Council's previous submissions on this development raised concerns regarding the long term impacts of the carparking solutions for this development. In particular the provision of above-ground parking, surface and multi-storey, to the north of the site on prime potential recreation grounds that are adjoining and upland of bushland and riparian areas, and visible from the residential areas across the valley.

3) A minor alteration to the approved location and internal flow of the multi-deck carpark (bringing the structure closer to the hospital wings and allowing pedestrian access at the one level); and

**PLEASE REFER TO ATTACHMENTS 1,2,3,4,5 – mark ups of drawings**

**Table 1 – Alterations to Levels of the Modified Multi-Deck carpark**

Front Entry Building Level 1

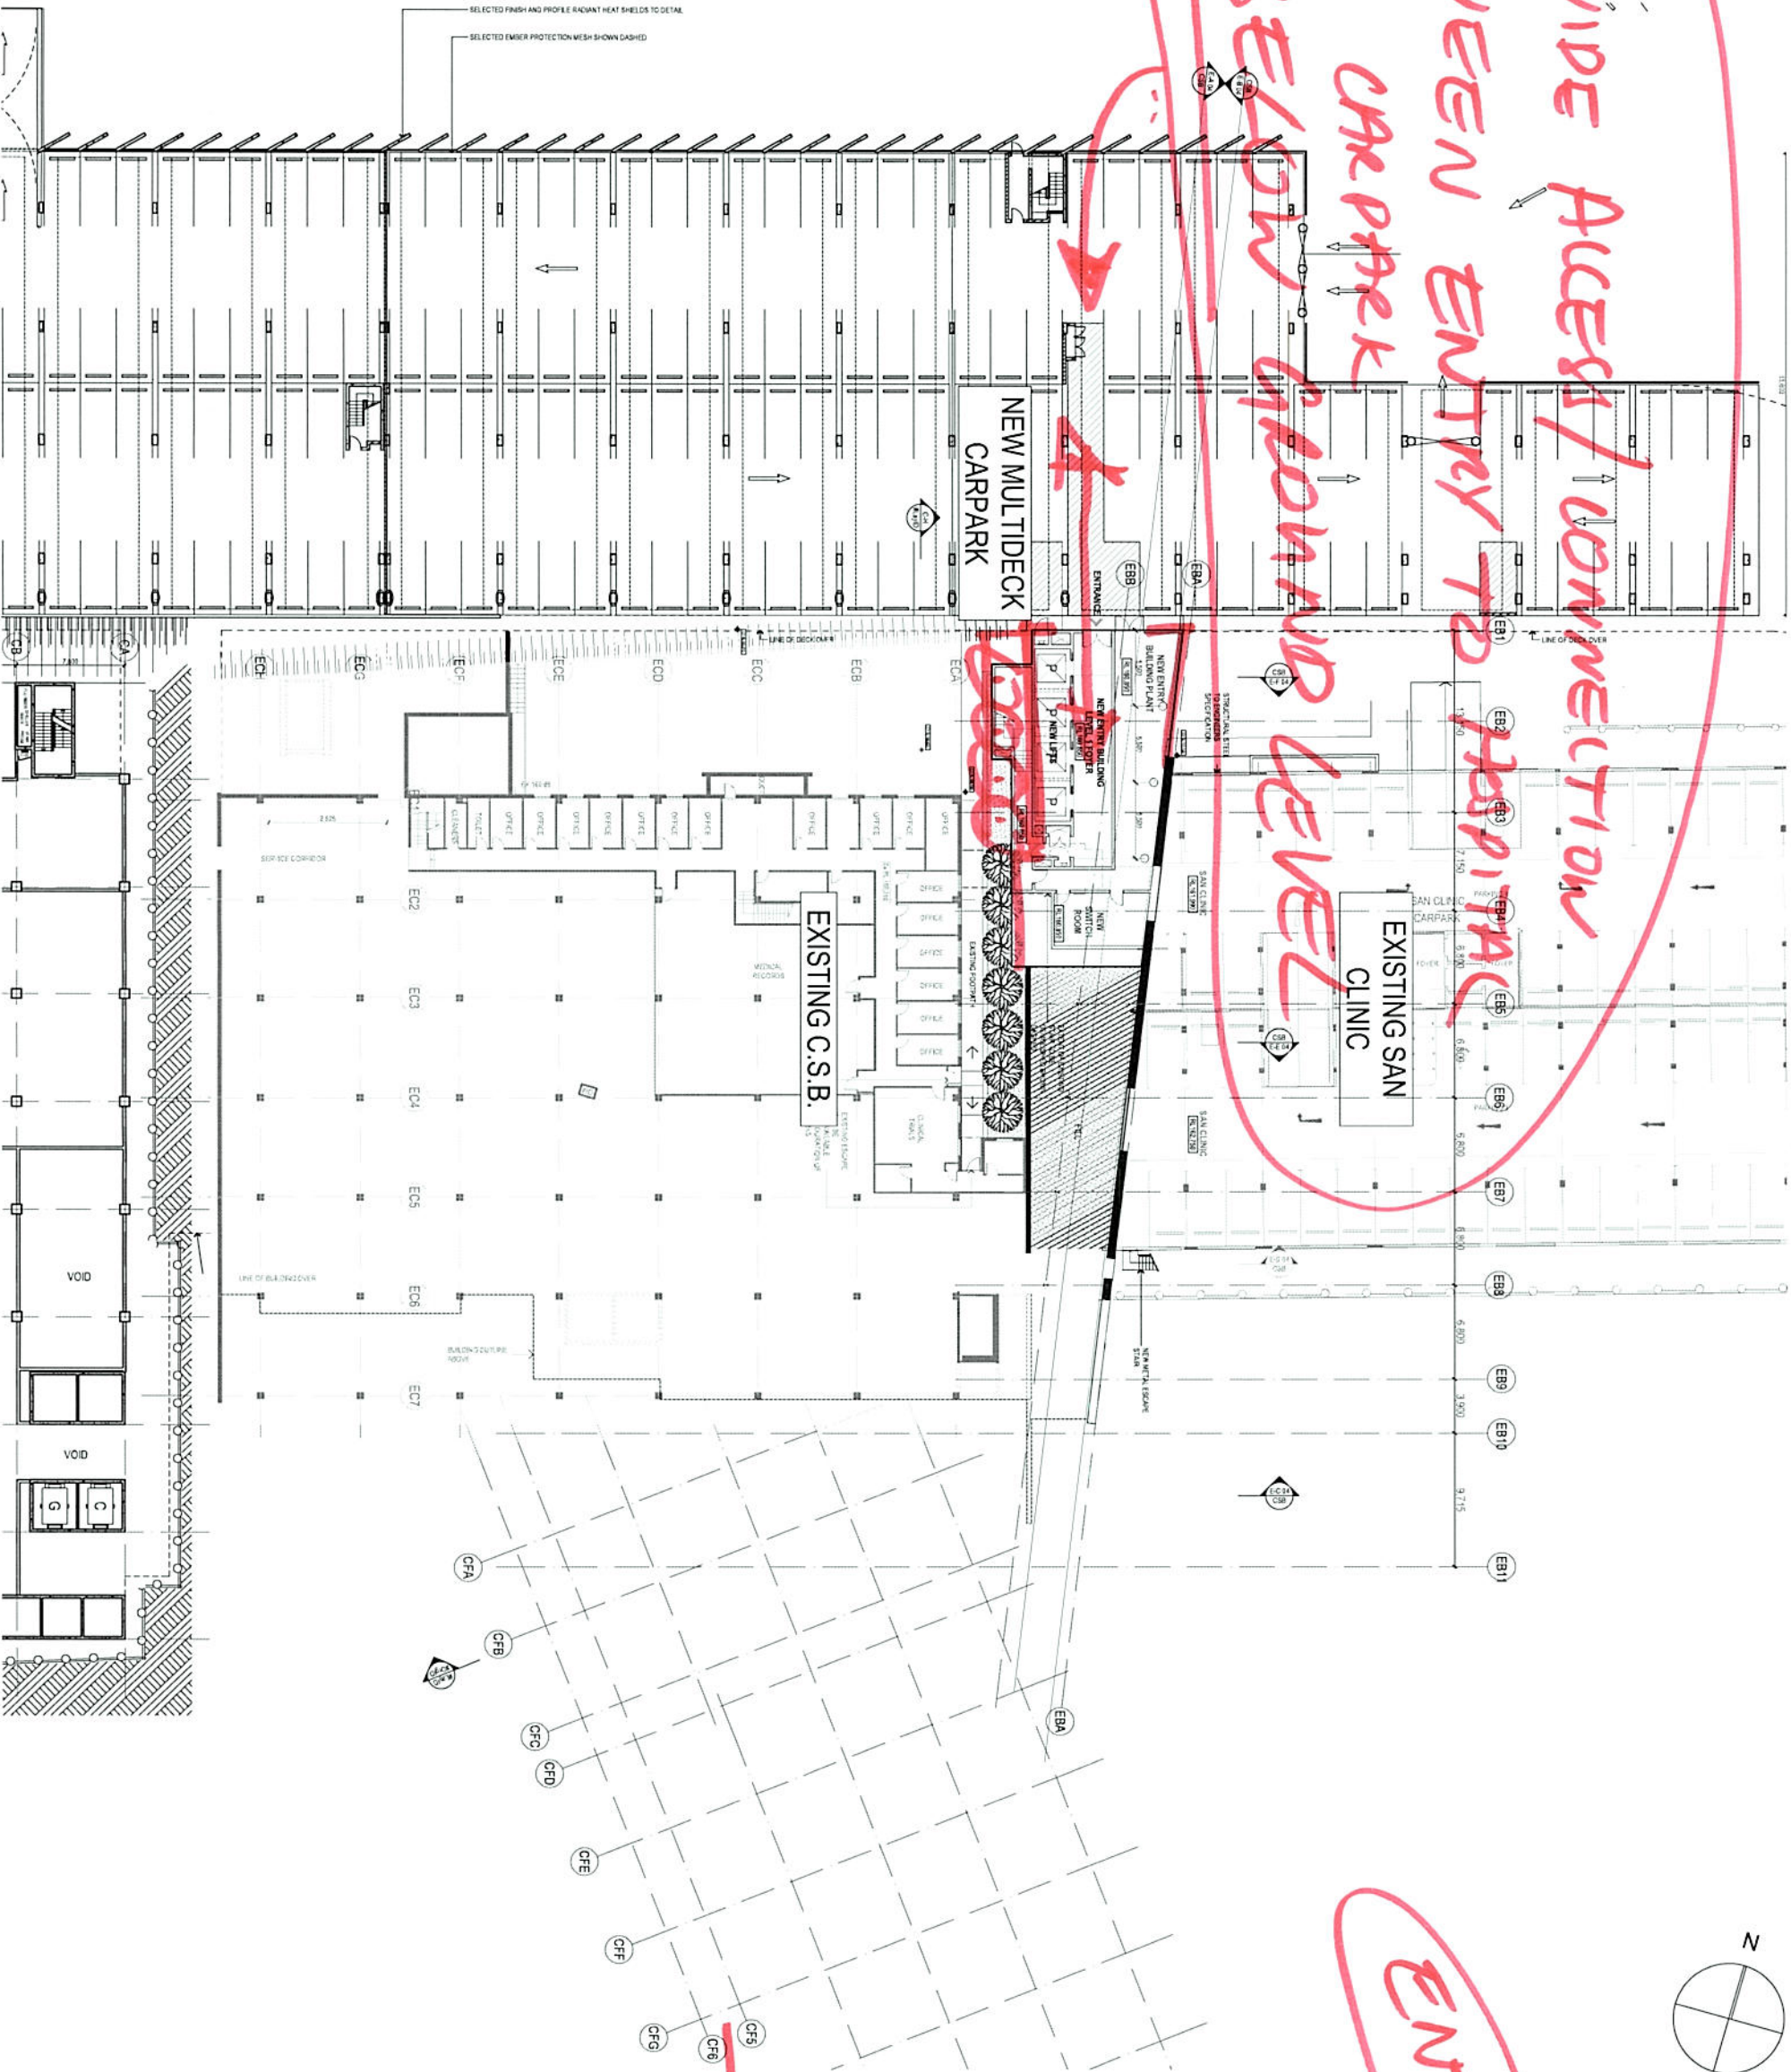
RETAIN/  
PROVIDE  
VISUAL ACCESS  
AND SOLAR  
ACCESS  
North

REMOVE  
Solid Walls

REMOVE  
Compound  
Above - Ground  
CARPARK
